Architectural Review and Historic Preservation Board Agenda Report

File : AR 20-13

RE: A 4-plex for French Homes at 192 E. 1st Avenue (APN 003-101-012)

SITE PLAN

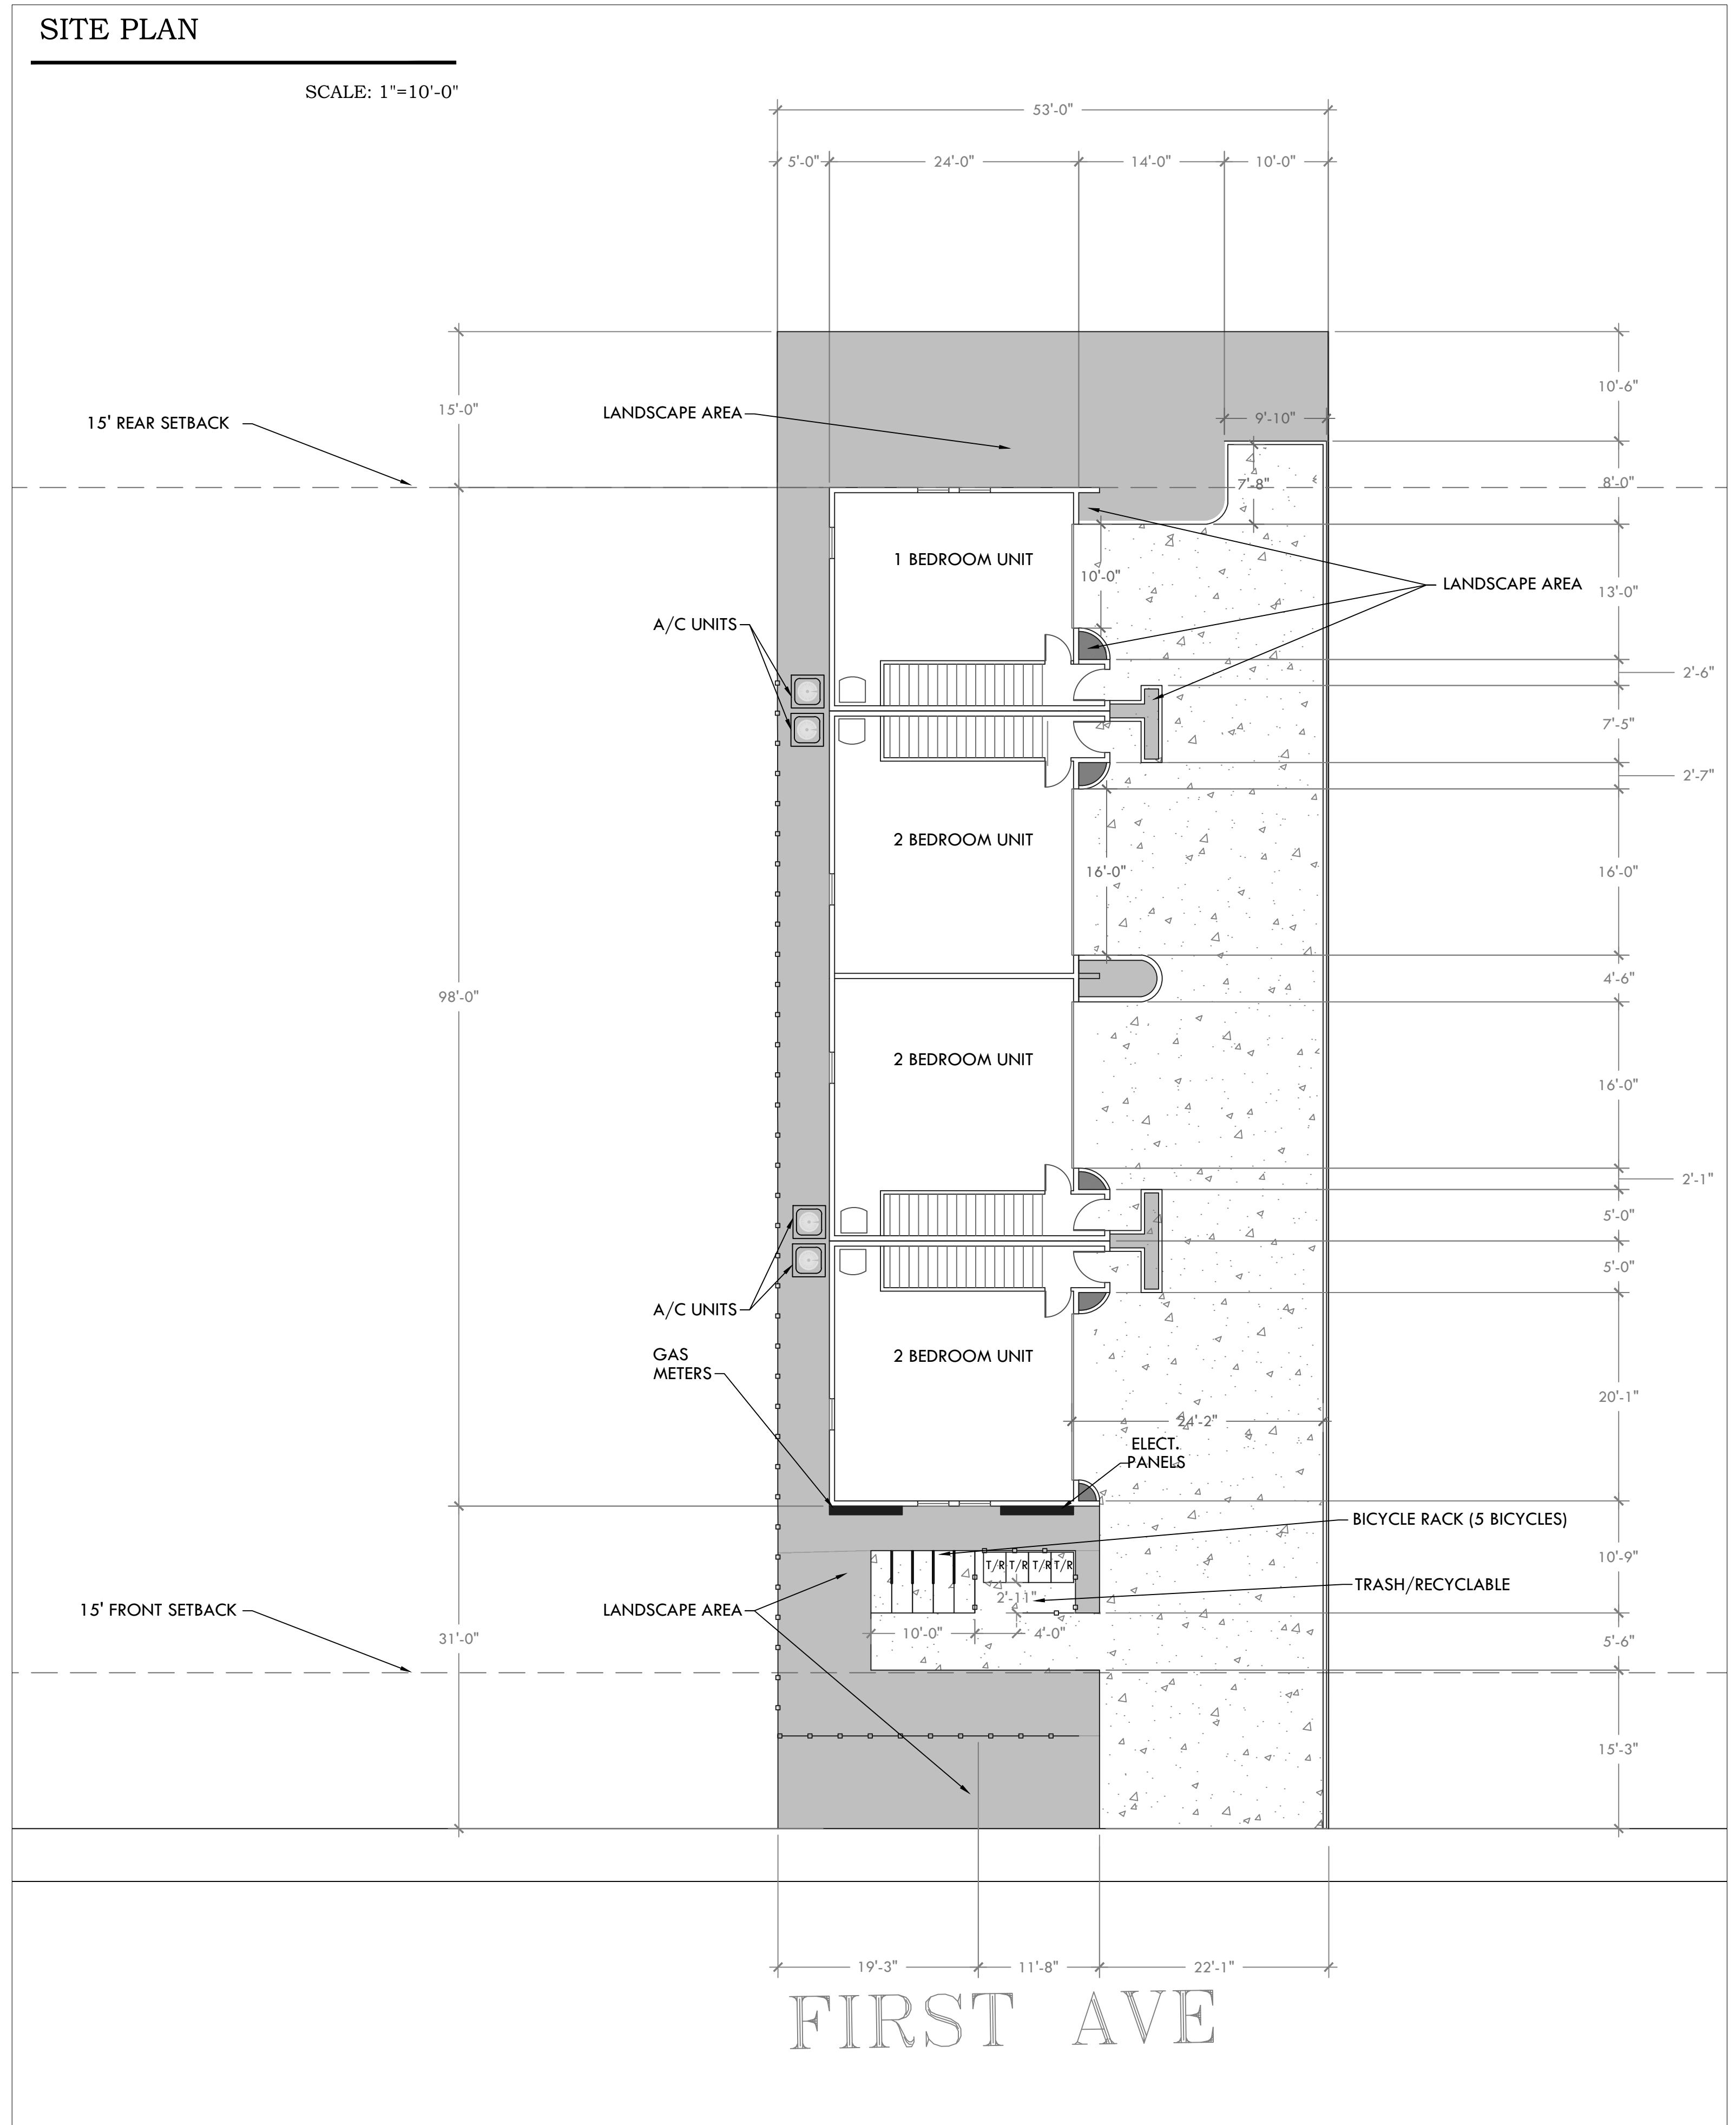
The site plan shows a 6-foot, dog-eared fence across the front yard. To better meet the DGs, staff recommends **Condition #3** to require to a cap and rail atop the fence to reduce monotony along the street side of the project and convey a sense of permanence, better meeting DGs 4.2.31. Additionally, a covered trash enclosure is proposed in the front yard area. Staff recommends adding **Condition #4**, to either change the fencing around the covered trash enclosure to match the cap and rail style fence or upgrade the trash enclosure to a design that better matches the building architecture.

Parking lot shading would meet the code requirement, with 58% of the parking area projected to be shaded in 15 years. The R3 district requires 35% of the area to be landscaped however this site plan shows on 29% of the project site being landscaped. Staff therefore recommends **Condition #6** to ensure the project meets this requirement.

3. Upgrade the 6 ft dog-eared fence along the front yard to a cap and rail style to reduce monotony along the street side façade
4. Change the fencing around covered trash enclosure to match the cap and rail style fence or upgrade the trash enclosure to a design that better matches the building architecture.

6. Subject to Planning staff approval prior to issuance of a building permit, a revised, detailed, final landscape plan shall be submitted. The landscape plan shall meet the 35% landscaping requirement for R3 zoning district. Additional landscaping can be provided in the open space area in rear of the lot or by increasing the landscaped planter area in front of each unit.

7. AC condenser units shall be moved such that they do not encroach within the required 3ft side yard setback from accessory structures.

LANDSCAPE PLAN

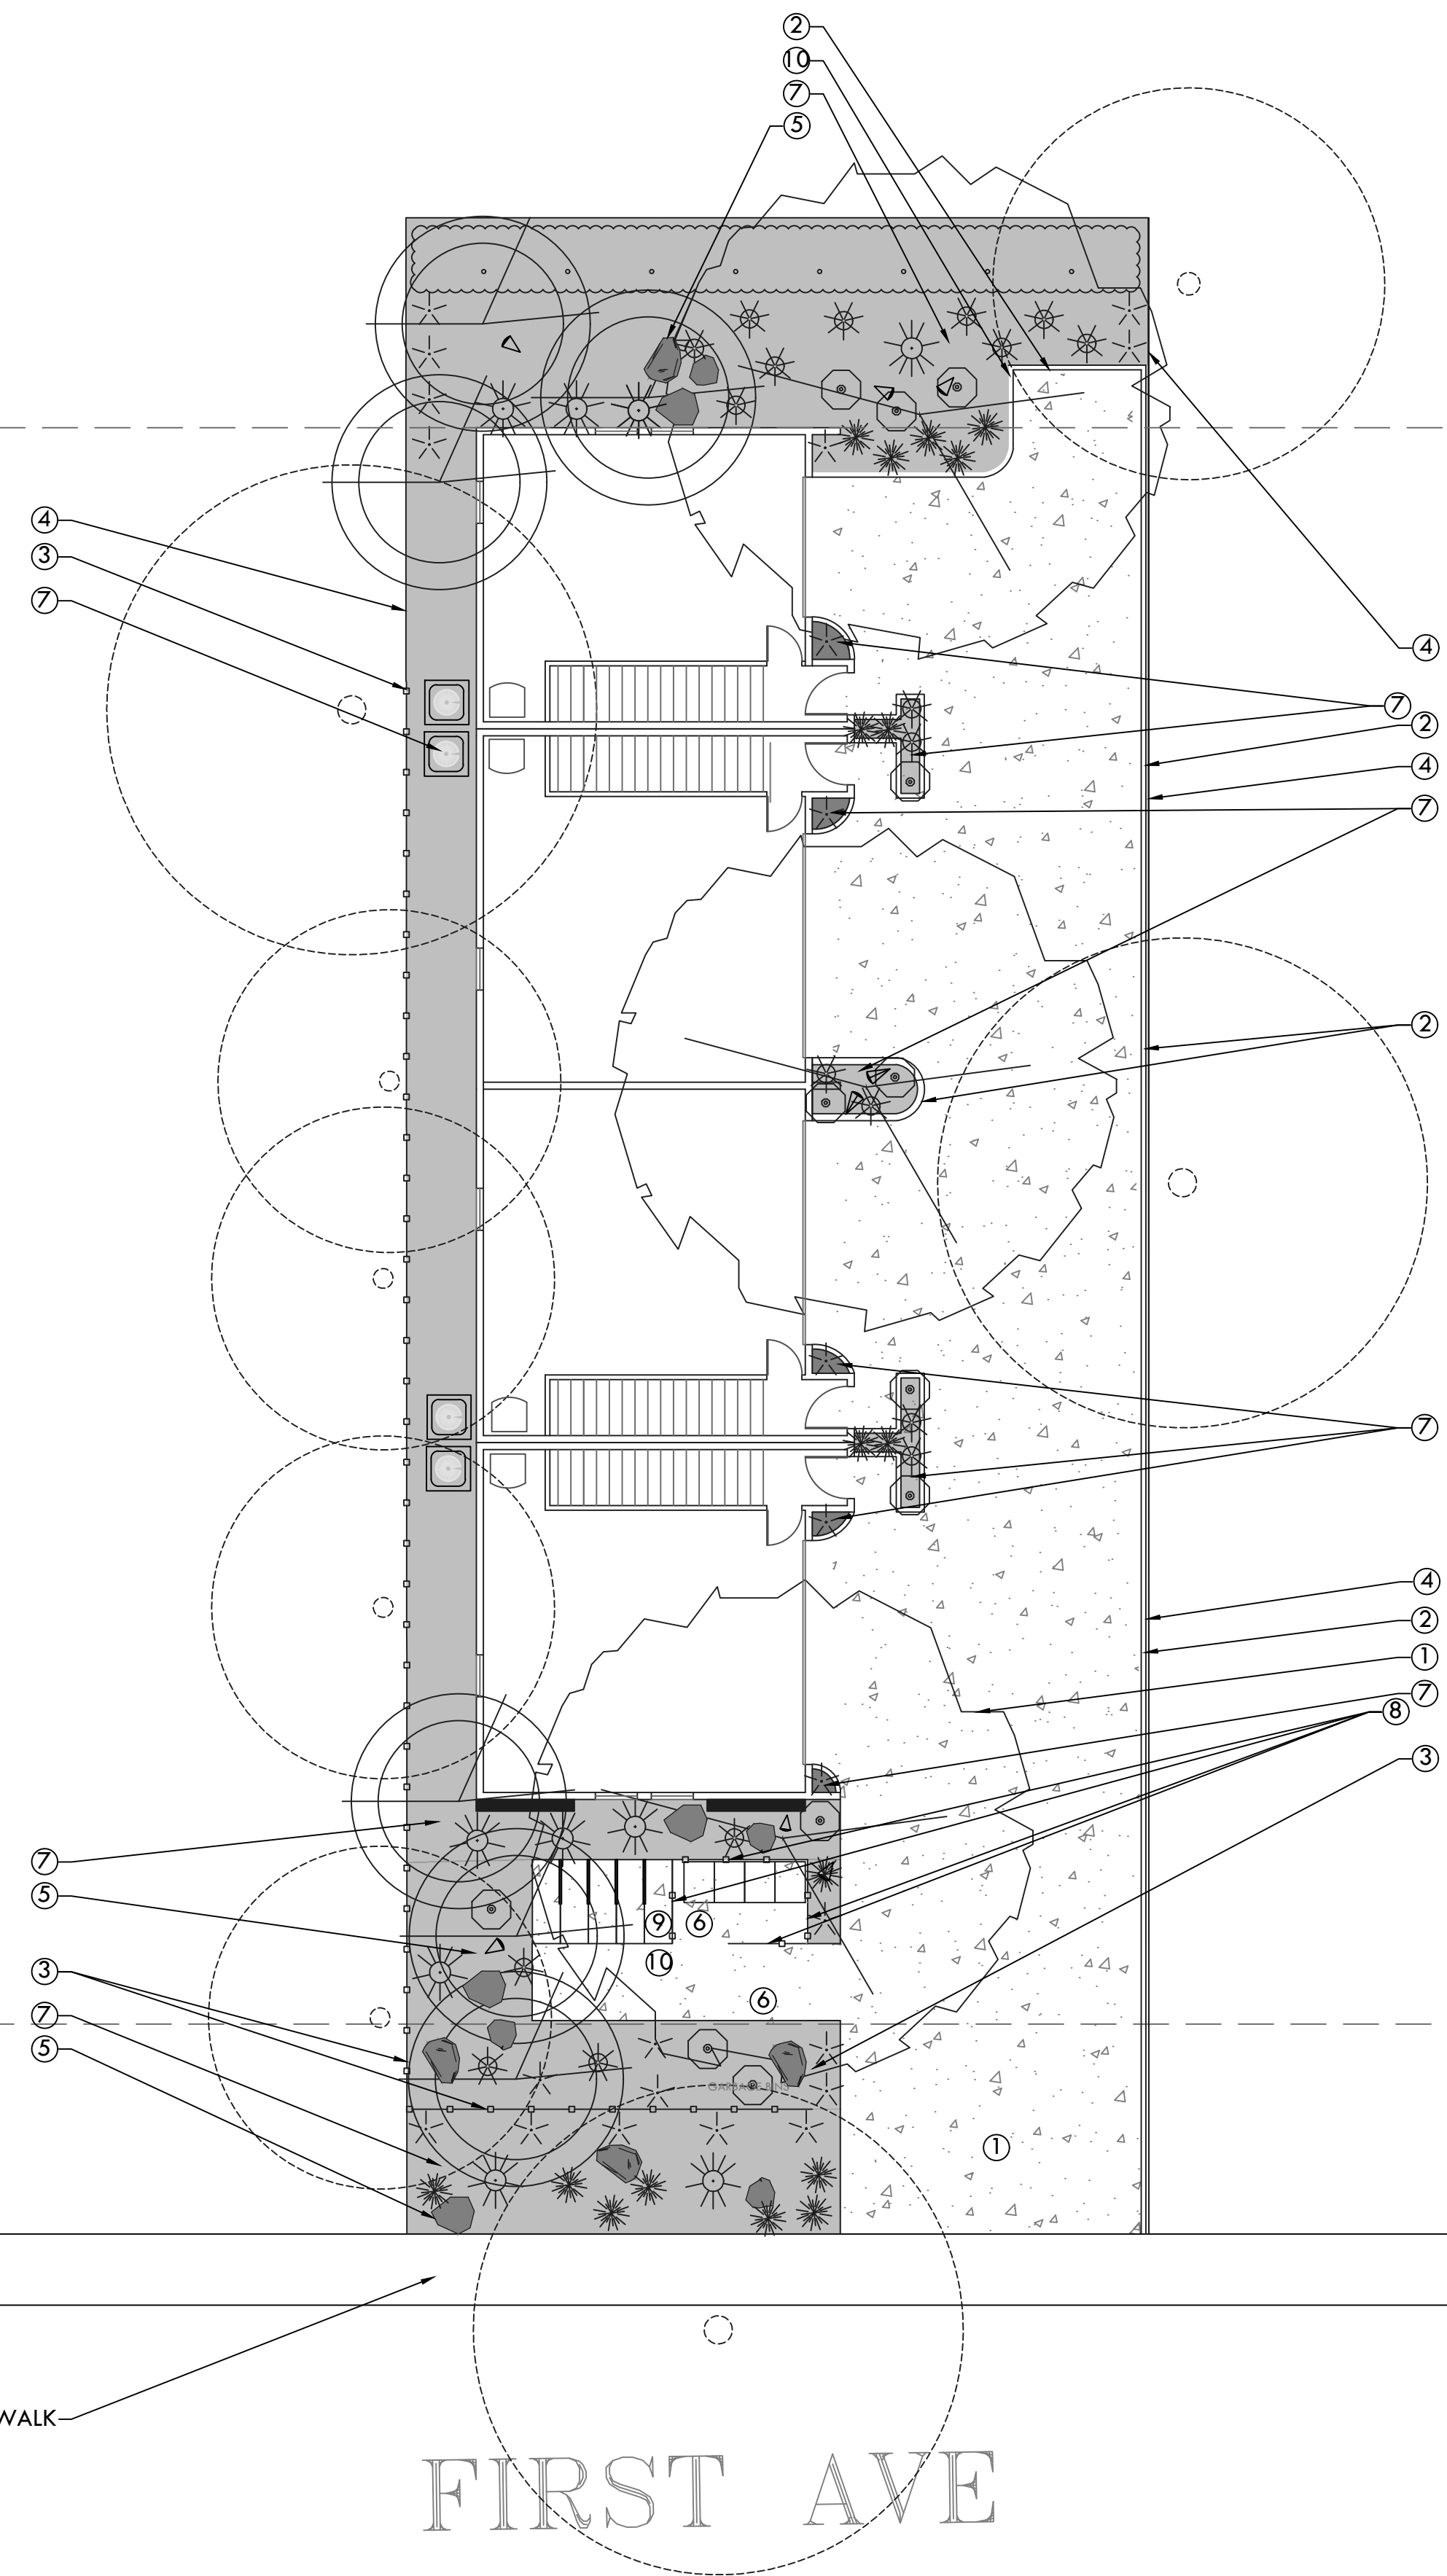
There is very little room to provide usable open space at the site, however an opportunity appears to exist for a common patio area in the back of the lot. To achieve better consistency with the DGs, specifically DG 4.1.42 and DG 4.1.43, **Condition #5** is recommended to require constructing a new surface of paver stones, bricks, or similar with patio cover/ trellis at that location to create a usable, shared outdoor recreation area.

5. A usable outdoor area with all-weather surface shall be constructed in the rear of the lot by constructing a new surface of paver stones, bricks, or similar with a patio cover/trellis.
